TG03 - Buttress, Shoring, Buttress - Issued for Bid

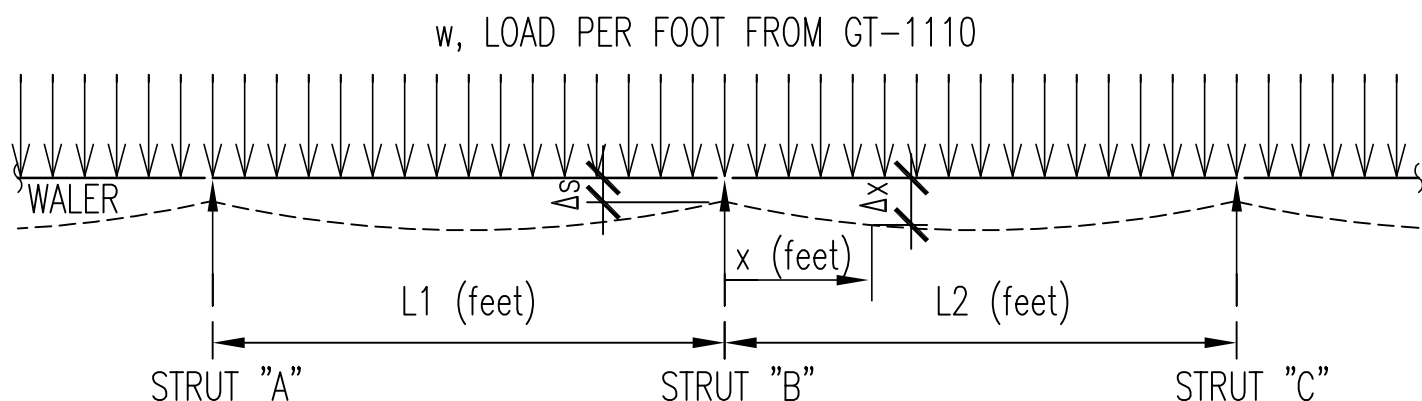
TG0300-0085	8/19/2010	Reference drawing sheet GT-2103. Is cutoff wall between grids 33 & 34 required? Schedule appears to show excavation on both sides of this wall going down at the same time.	Refer to Note 12 on drawing GT-2101 regarding location of the cut-off walls.
